M5 Junction 10 Improvements Scheme

Applicant Written Submission of Oral Case for Issue Specific Hearing 3 (ISH3)

Rule Number:	Rule 8 (k)
Planning Inspectorate Scheme Reference	TR010063
Application Document Reference	TR010063/APP/9.68
Author:	M5 Junction 10 Improvements Scheme Project Team

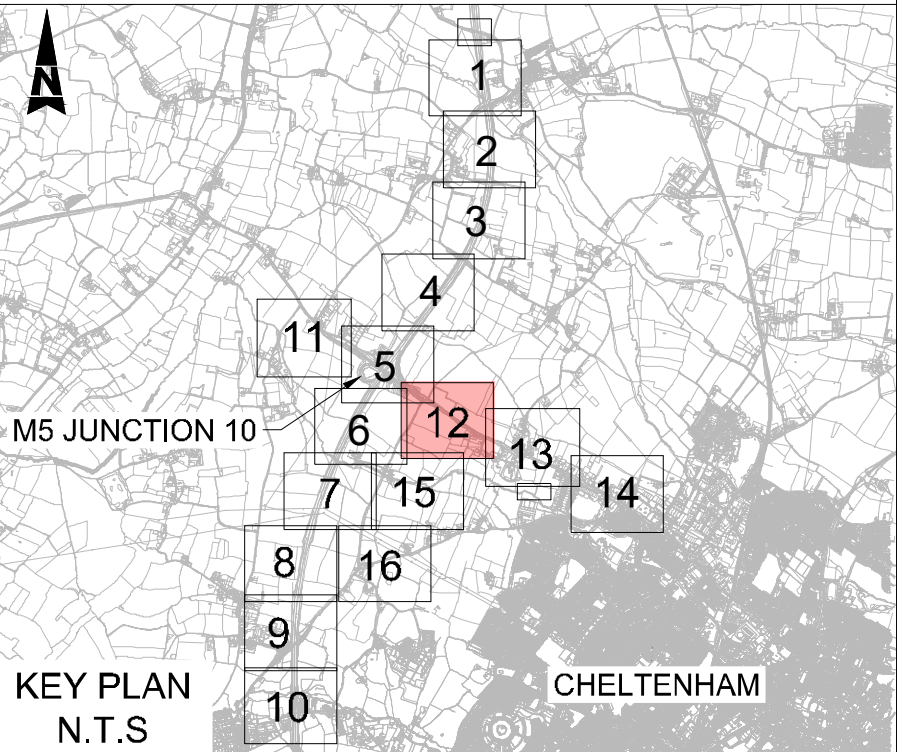
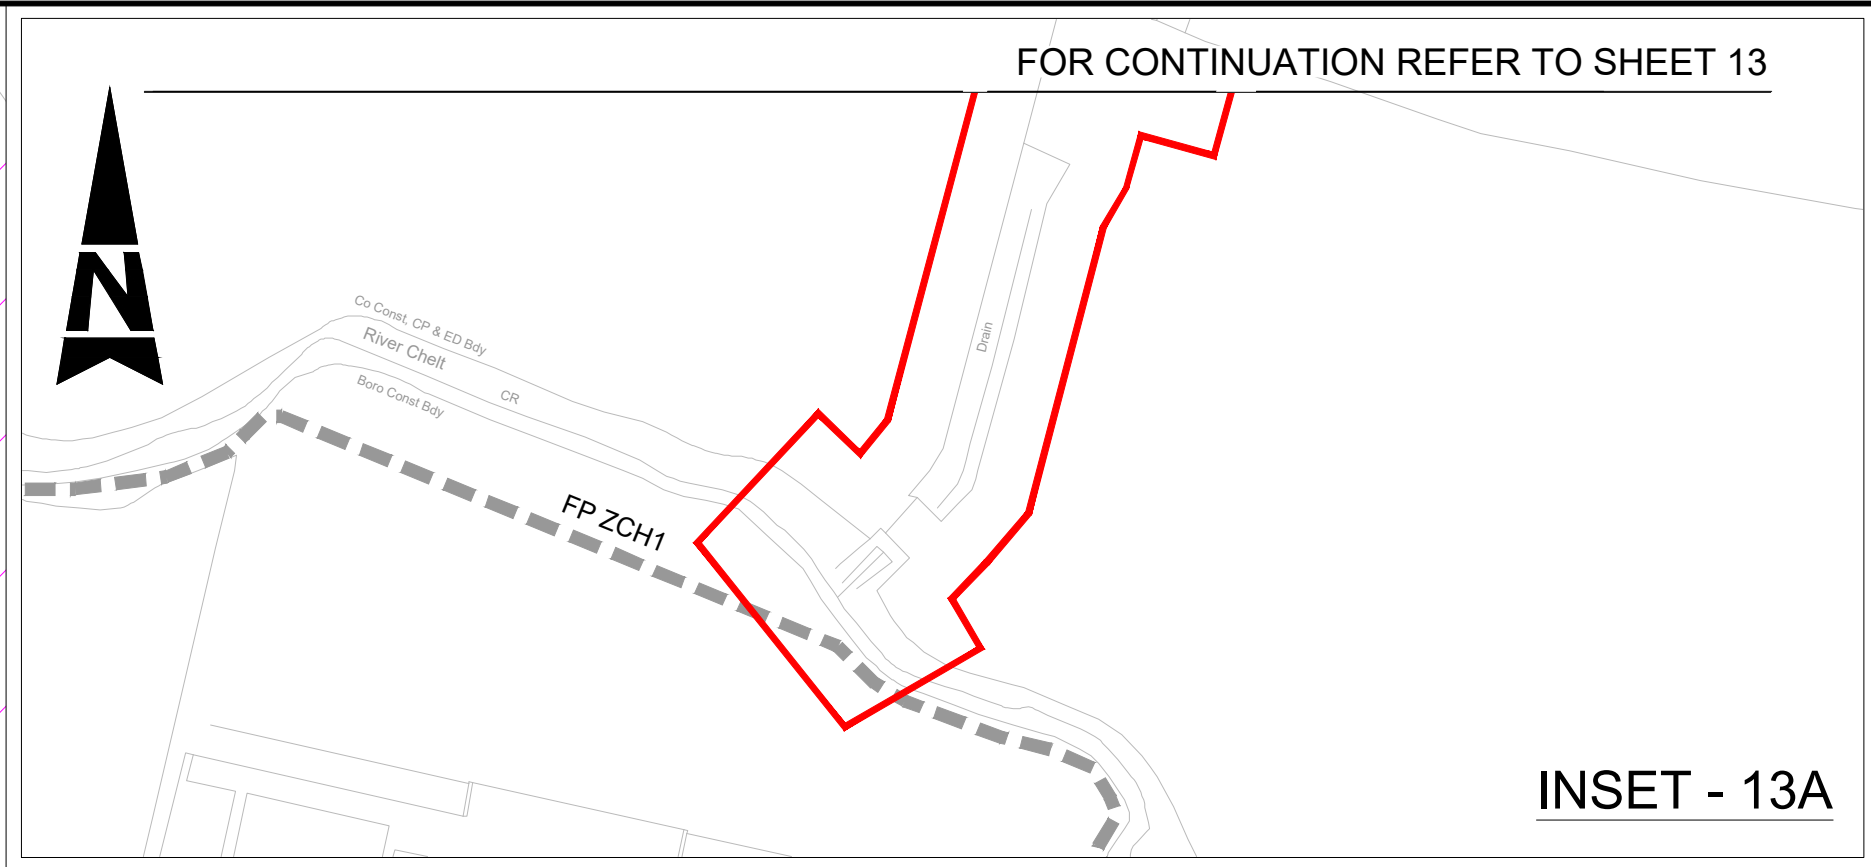
ISH3.15	<p>The Applicant was requested to provide two plans: one overlaying the current highway boundary and a second against the future adopted highway boundary to understand existing and future relationships between adopted highway and land parcels today and in the future.</p>	<p>Please see requested plans to address ISH3.15 in Appendix C to this document. The statements below set out the change each landowner will experience regarding highway frontage.</p> <p>The plans show the freehold ownership of Elizabeth Counsell and Mary Bruton hatched orange and the freehold ownership of Gillian Moore, Harry Carter, Jacqueline Pinkerton and Shirley Carter hatched magenta. This is the same of both sheets of the works plans and general arrangement plans. Bloor's interest covers both the orange and magenta hatched land. The plans also show the revised highway boundary as a result of the Scheme to demonstrate where highway frontage will be once the Scheme is completed.</p> <p>Both sets of plans demonstrate that the landowners will have the same extent of road frontage following the scheme as before the scheme. Moreover, Elizabeth Counsell and Mary Burton will have an increased frontage onto the A4019. This will result from the highway boundary moving further north beyond the properties Laburnum and Withy Bridge, which will be demolished by the Scheme and are between the land and the A4019. This will increase the frontage from approximately 100 metres to 185 metres. In addition, the change in alignment of the current south bound slip road will</p>

Action Point Ref.	Action Point Description	Applicant Response
		<p>mean that the gyratory will be substantially further west than the end of the current slip road, which would be an improvement in respect of an access directly onto the A4019 at this location.</p> <p>There is greater separation between the carriageway and the land owned by Elizabeth Counsell and Mary Bruton because of the Scheme, but an access in this location is no less deliverable following the Scheme than currently from a highway perspective.</p> <p>The private means of access that will serve Elizabeth Counsell and Mary Bruton, Robert Hitchens Limited and Rule Meadow would run along the frontage of the land owned by Elizabeth Counsell and Mary Burton following the Scheme. This could though be simply altered to interact with a new access directly into the land owned by Elizabeth Counsell and Mary Bruton from the A4019 and does not restrict an access at this location.</p> <p>The ability to construct an access for a large-scale development directly from the A4019 into the land owned by Elizabeth Counsell and Mary Burton, is currently very challenging. The obvious large scale development access point being from the land owned by Gillian Moore, Harry Carter, Jacqueline Pinkerton and Shirley Carter, or through the land owned by Gloucestershire County Council. Given Bloor's interest across both the orange and magenta hatched land this would be most likely through the pink hatched frontage and still could be. The access to the land owned by Elizabeth Counsell and Mary Bruton is no more challenging following the Scheme than in a no Scheme world, and as such there is no more ransom, or commercial advantage, benefitting Gloucestershire County Council as a result of the Scheme.</p>

Appendix D. Current road frontage plan in response to ISH3.13

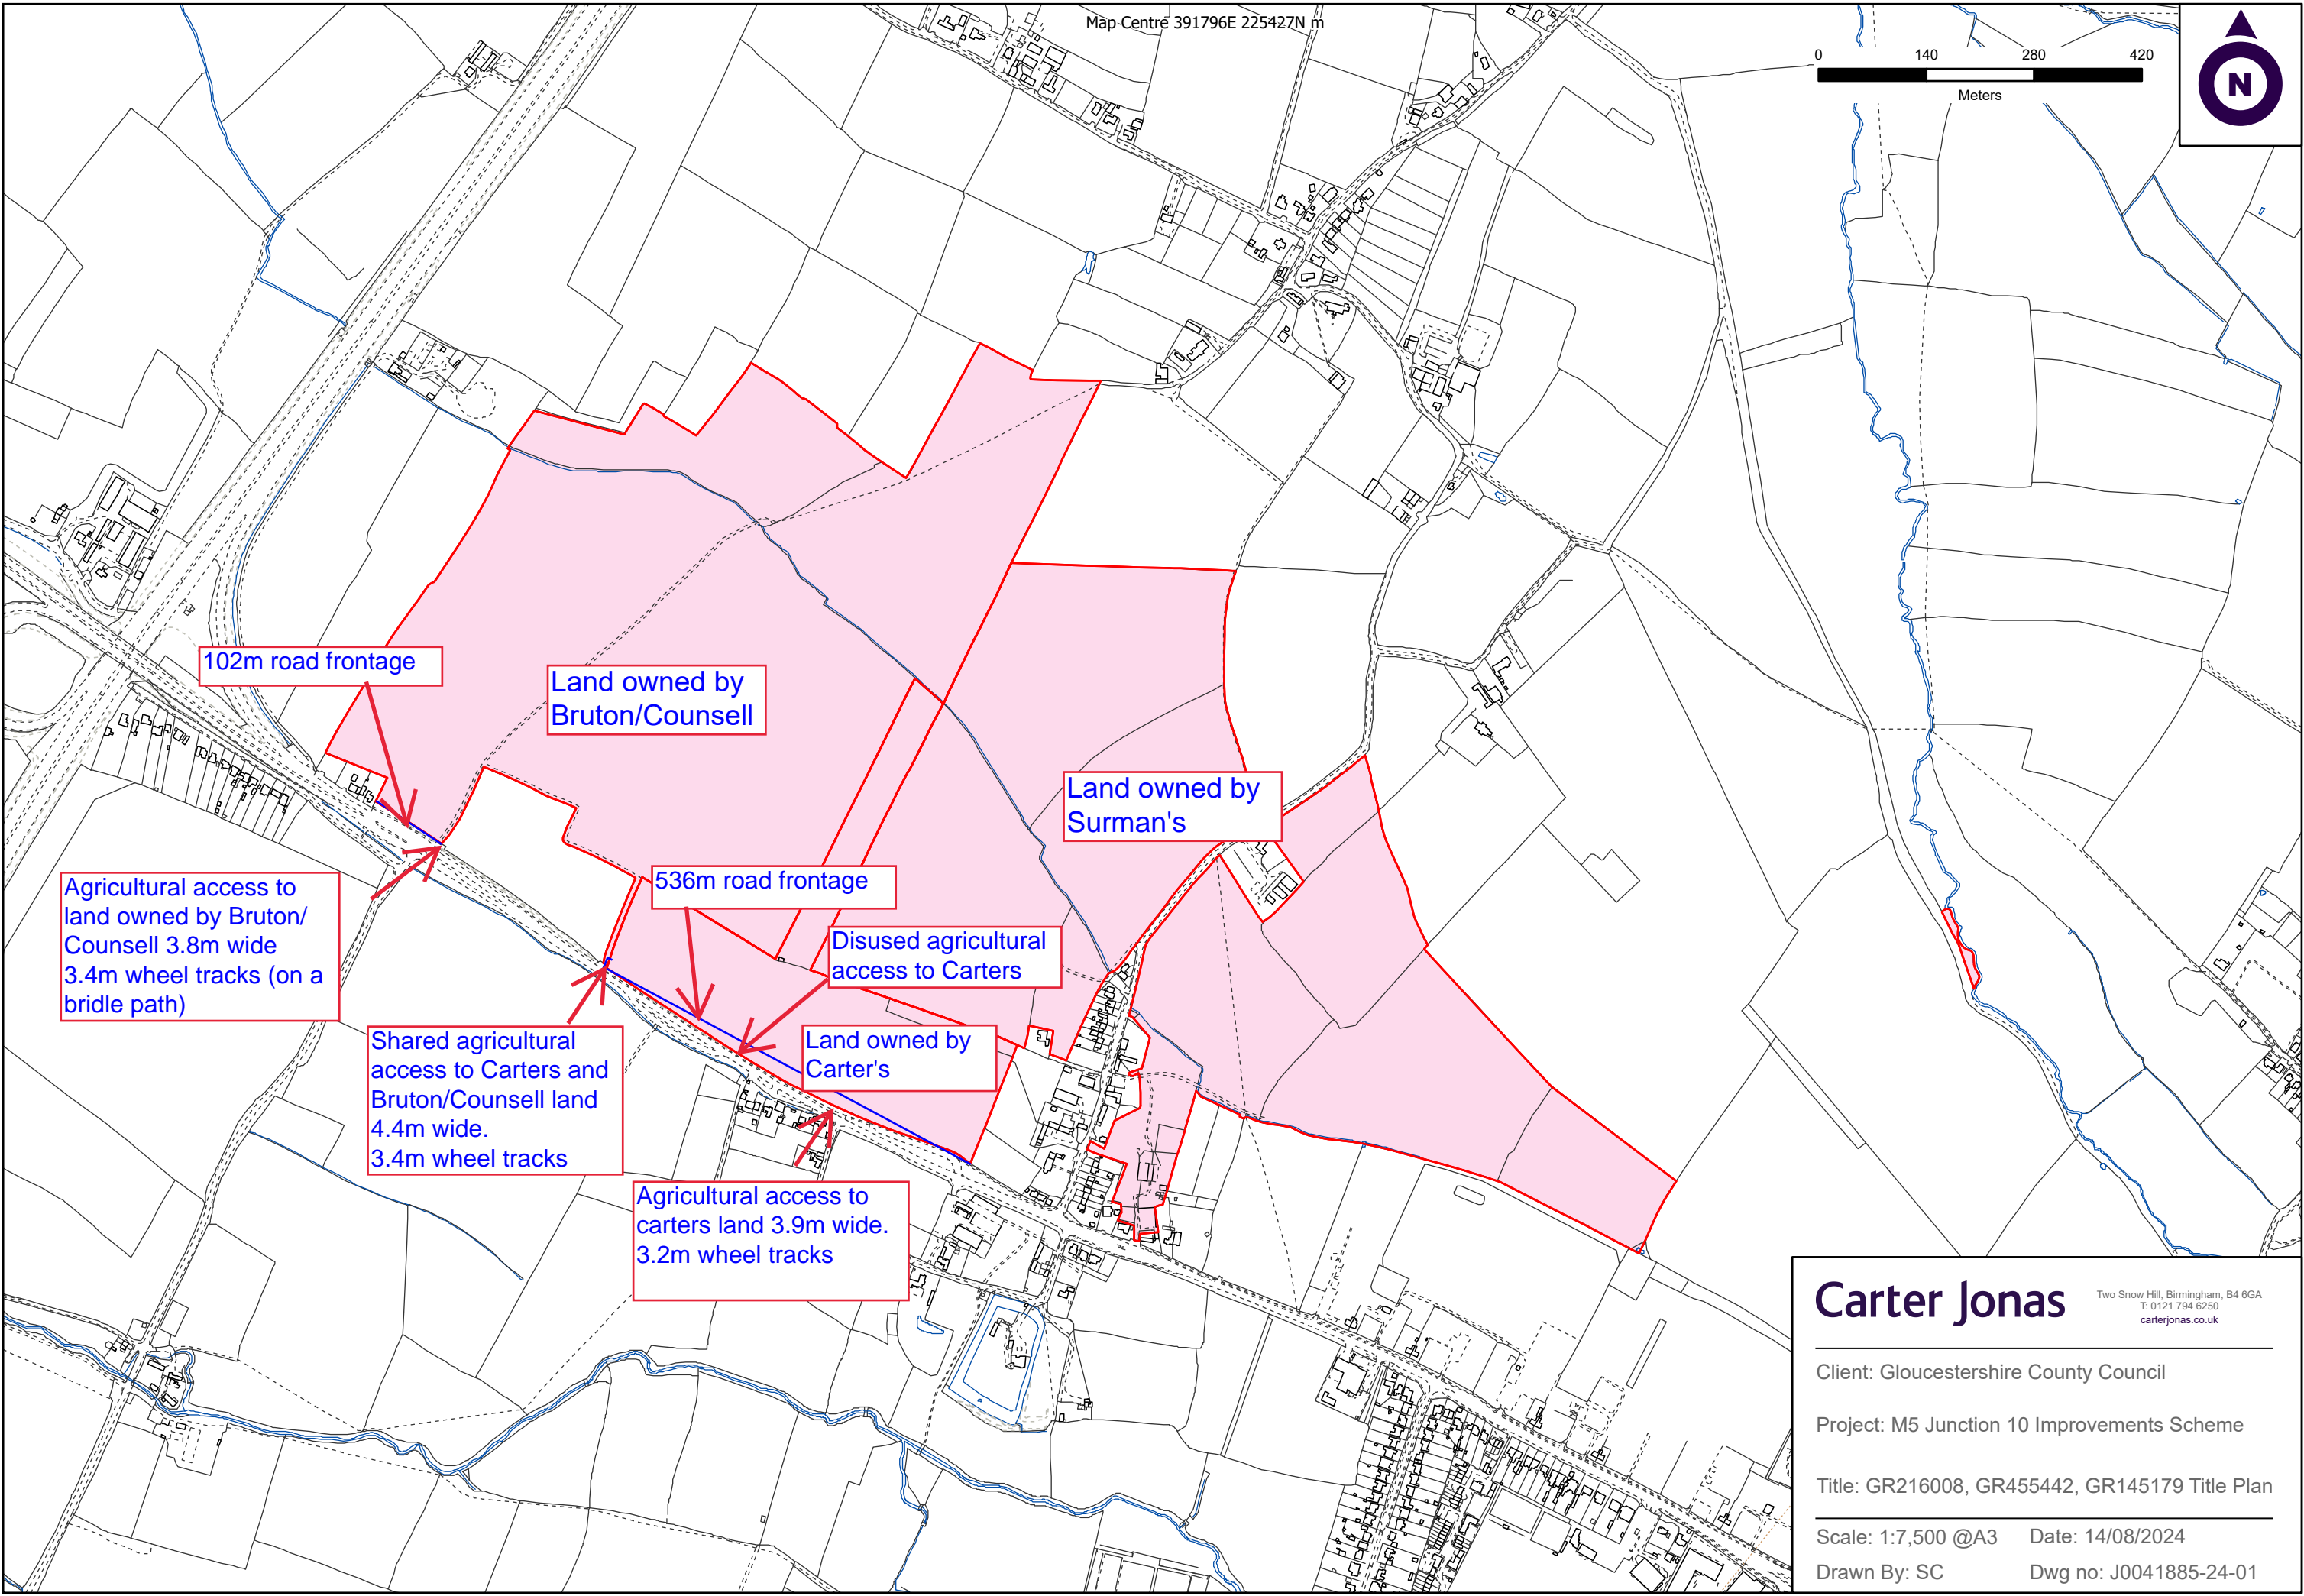
<p>ISH3.13: The Applicant was asked to provide clarity on the width of access points to fields north of the A4019 and how those fields are being farmed. The Applicant was further requested to comment as to the relative betterment or detriment of its proposals.</p> <p>ISH3.14: The Applicant was asked to confirm whether the safety incidents referred to on the A4019 involved farming movements and activity associated with farm accesses.</p>		
<p>ISH3.15: The Applicant was requested to provide two plans: one overlaying the current highway boundary and a second against the future adopted highway boundary to understand existing and future relationships between adopted highway and land parcels today and in the future.</p>		
(iv)	<p>The Applicant and National Highways will be asked to explain their positions with respect to all Departures from Standard sought in the Safety Report submitted at Deadline 2.</p>	<p>When developing the Scheme, the Applicant's consultants held a call with National Highways Safety and Engineering Standards specialists for geometry on 8 September 2021. During the call the scope of the proposed slip road departures were discussed to assess National Highways' understanding of acceptability. The Applicant was asked to submit the departures into National Highways DAS system, where they were given 'Provisional Agreement' on 19 November 2021. National Highways' guidance states that Provisional Agreement may be given early in the Scheme life cycle by a Technical Specialist for a departure that is critical to Scheme success and, in principle, can be approved. A full application is</p>
